SUBJECT: Hydraulic Analysis of the Proposed Zinfandel Estate Subdivision

Appendix B – Response to June 9, 2021 comments received from River Focus Water Resources Consultants.

Figure A5: Proposed velocities for the 10-yr (top) and 100-yr (bottom) floods.

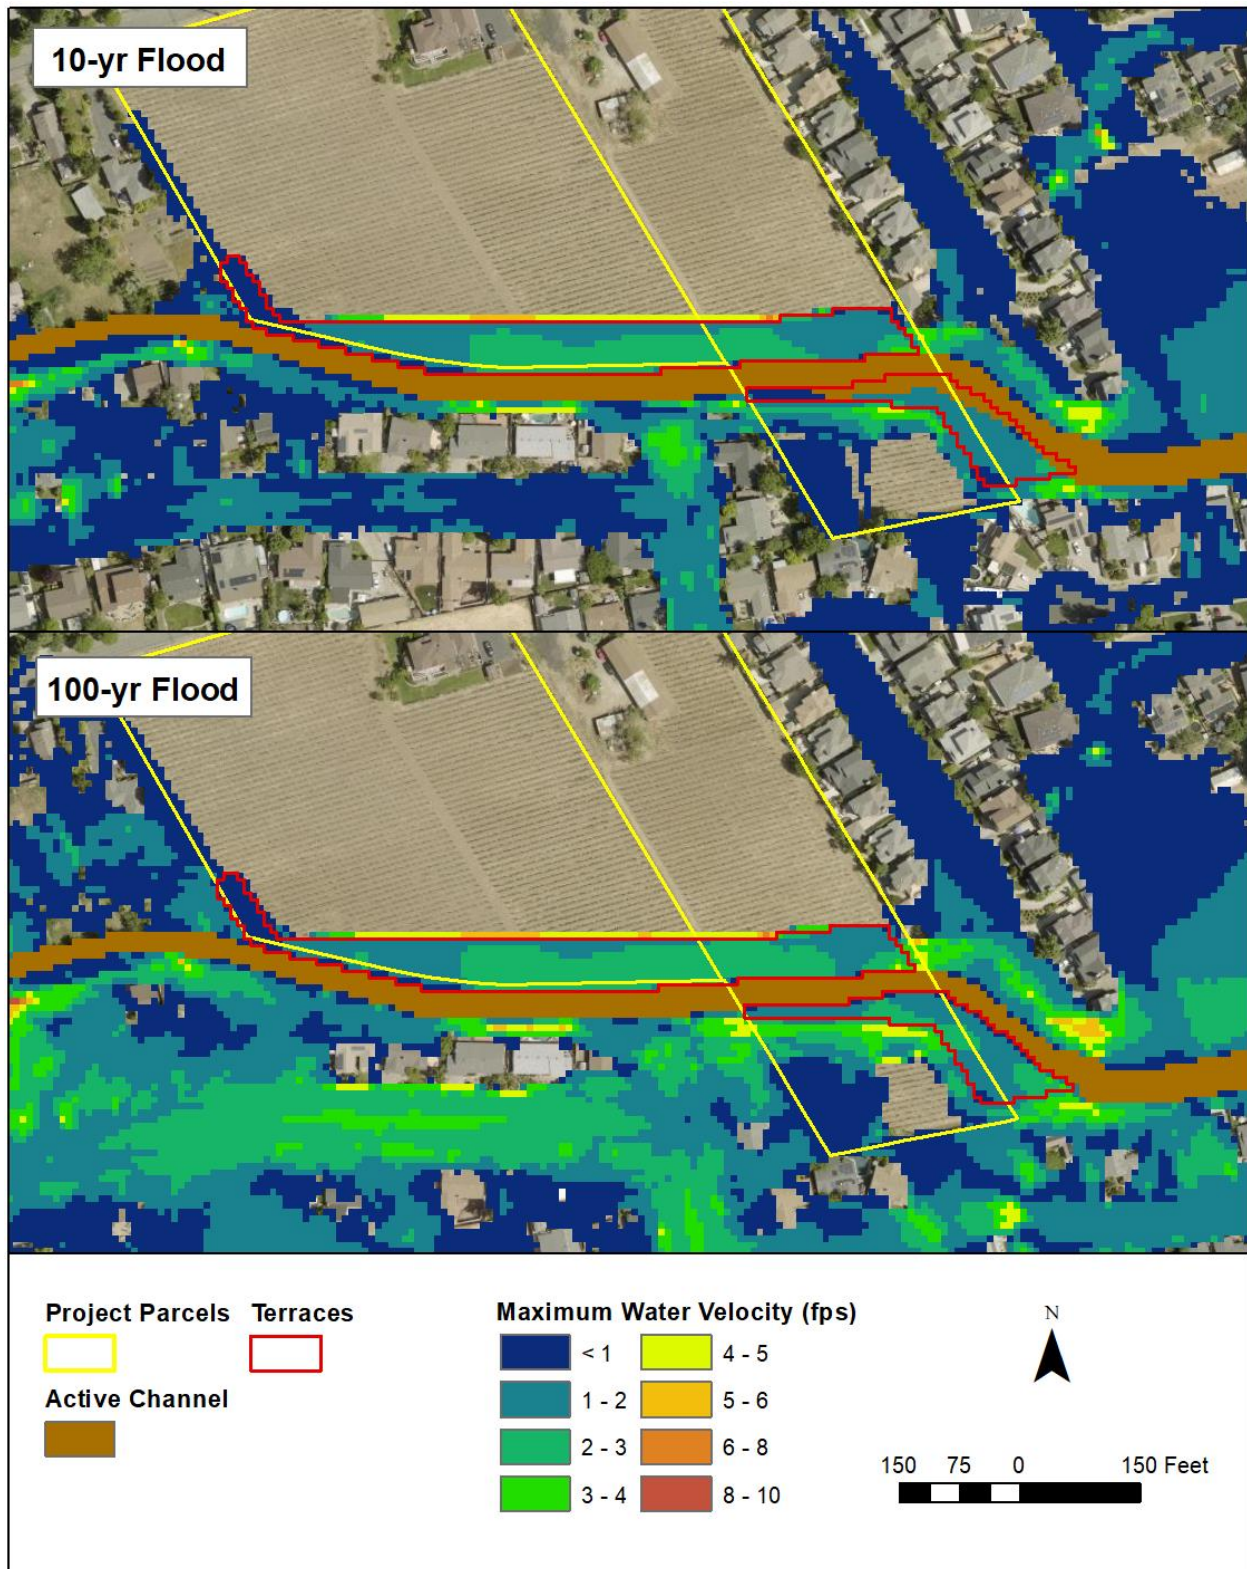
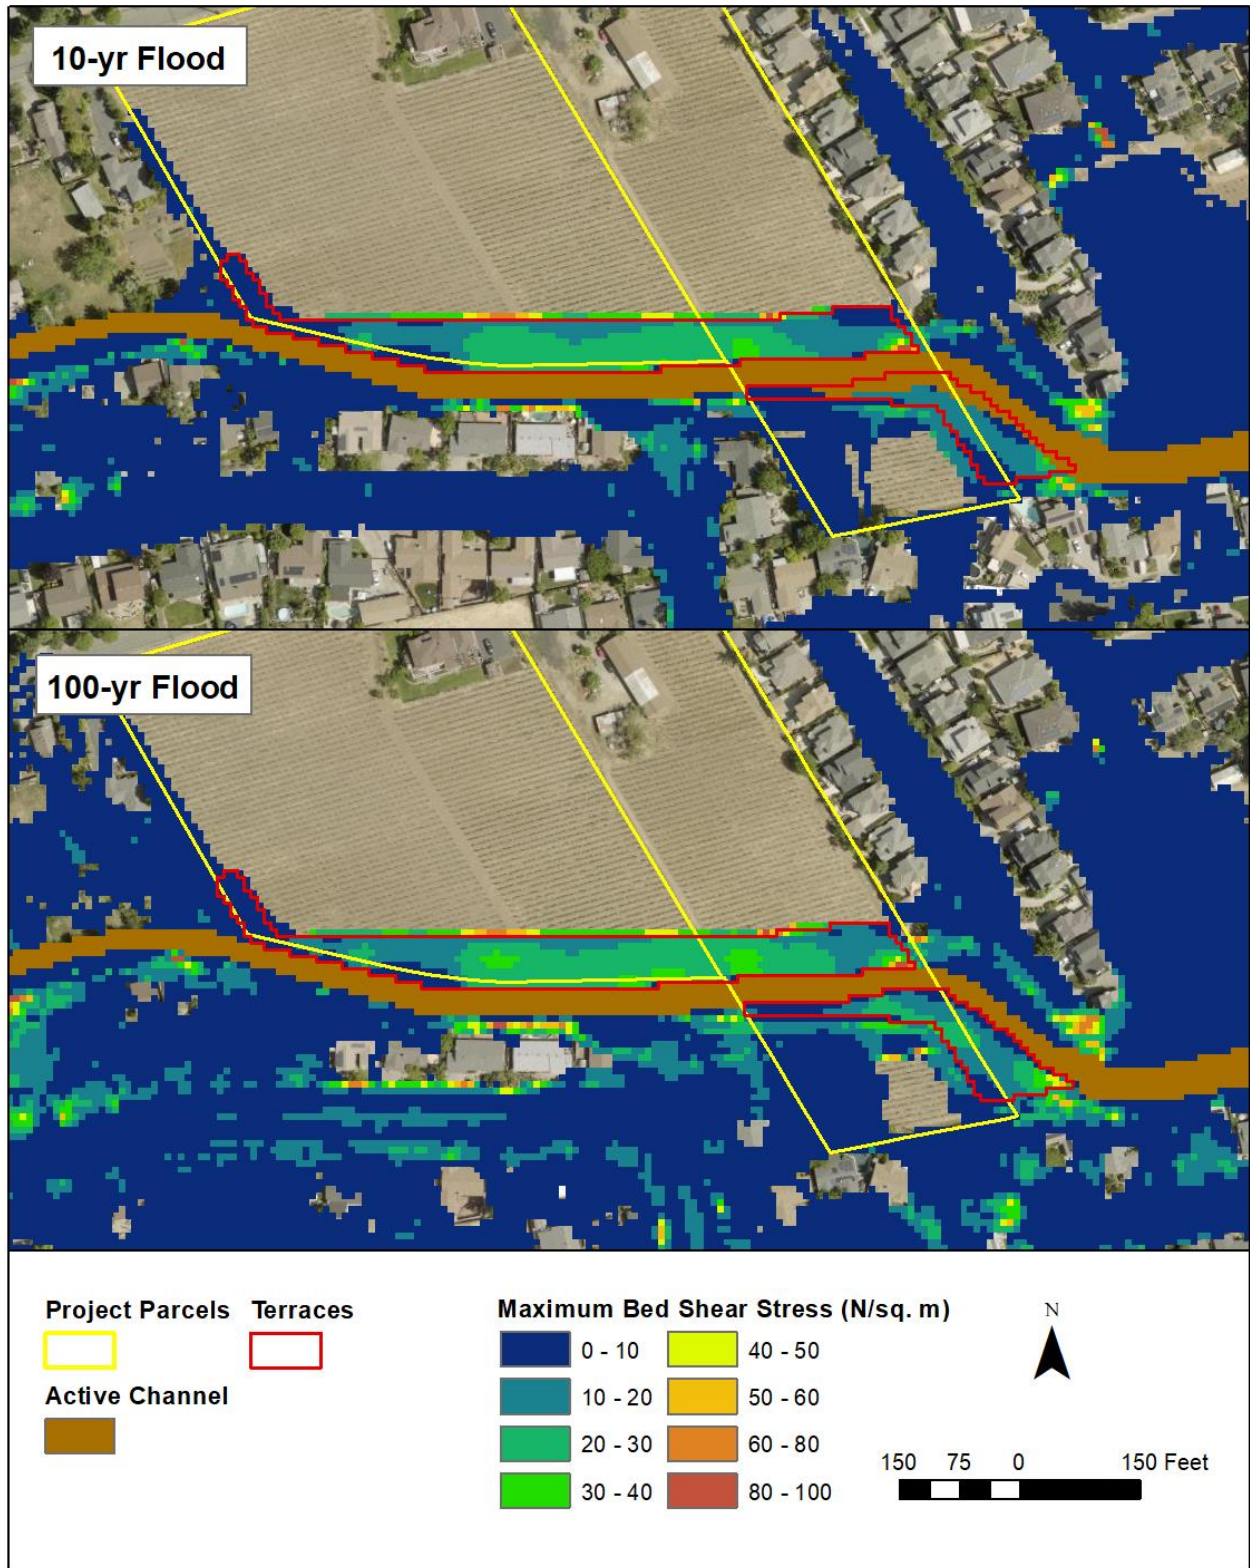
8. Please provide velocity and shear stress results for the terraces and fill slopes along the terraces and verify that no additional protection is required.

9. Where floodplain flows are returning to the channel at the upstream end of the project (see Figure 4), the likelihood of bank erosion may increase. Please examine proposed vs. existing velocity and shear stresses specifically in this area.

The requested results are provided below in Figures A5 & A6. Maximum velocities and shear stresses on the terraces are ~2.3 fps and 35 N/m² respectively. These values indicate that additional protection beyond the planned planting of native grasses, shrubs, and trees is not necessary. Maximum velocities and shear stresses on the side slopes leading down to the terraces are ~7.2 fps and 100 N/m² respectively. These values indicate that these fill slopes do require additional protection in the form of 9-in d₅₀ or larger rock rip-rap which will be incorporated in the final design plans.

Floodplain velocities and shear stresses are both quite low in the area where floodplain flows return to the channel at the upstream end of the project on the north side of the creek (Figures A5 & A6) and there aren't significant increases in channel velocities associated with the project in this area (Figures A3 & A4), therefore increases in bank erosion are not likely to occur in this area and additional bank protection is unnecessary.
